ADDENDUM NO. 004

PROJECT NAME: Morrison Center Addition Project
UNL PROJECT NUMBER: **A126P003**
UNL BID INVITATION NUMBER: **909360-12**

CONSULTANT: Farris Engineering
ADDRESS: **11239 Chicago Circle**

ADDENDUM DATE OF ISSUANCE: May 3, 2012
DATE OF BID OPENING: **May 10, 2012**

Project:	Project No:	Addenda No:	Dwg Ref No:	NVM-0100
	Ken Morrison Life Sciences Research Center Addition	102002	4	Addenda Sht:	M-1
	Sheet Title:	Date:	Checked By:	Drawn By:	
	MECHANICAL SCHEDULES	5-3-2012	JMM		MDB

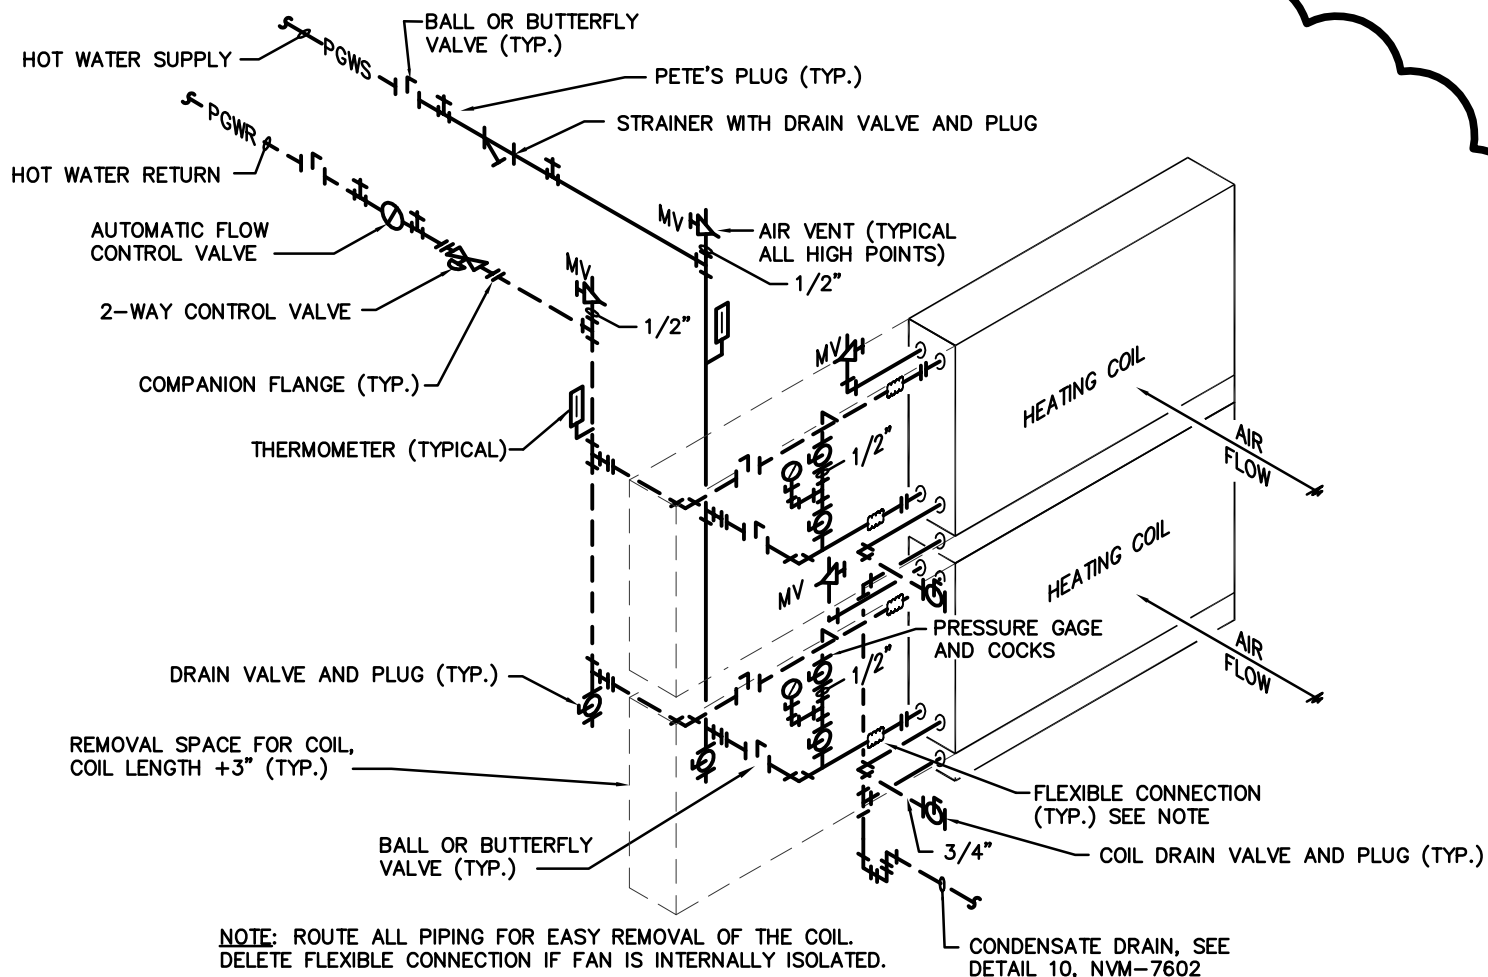
1. SHEET NVMW7000 MECHANICAL PLUMBING – BASEMENT FLOOR PLAN - EXISTING: Delete item 54 in Addendum No. 003, under the Changes to Drawings. No deductive credit is required.
2. SHEET NVMW0201 MECHANICAL PLUMBING – DOMESTIC HOT WATER FLOW SCHEMATIC DIAGRAM: Delete the three Mechanical Keynotes at the bottom of the sheet in their entirety.
3. SHEET NVM-0100 MECHANICAL SCHEDULES - FINNED TUBE RADIATION SCHEDULE: Revise schedule per attached sketch M-1.
4. SHEET NVM-7600 MECHANICAL DETAILS 8 and 9 :
 - A. Revise detail 8; LAV Supply VAV Box (LSAV), per attached sketch M-4.
 - B. Revise detail 9; Lab Exhaust VAV Box (LEVAV, FHVAV, GSVAV, CCVAV), per attached sketch M-5.
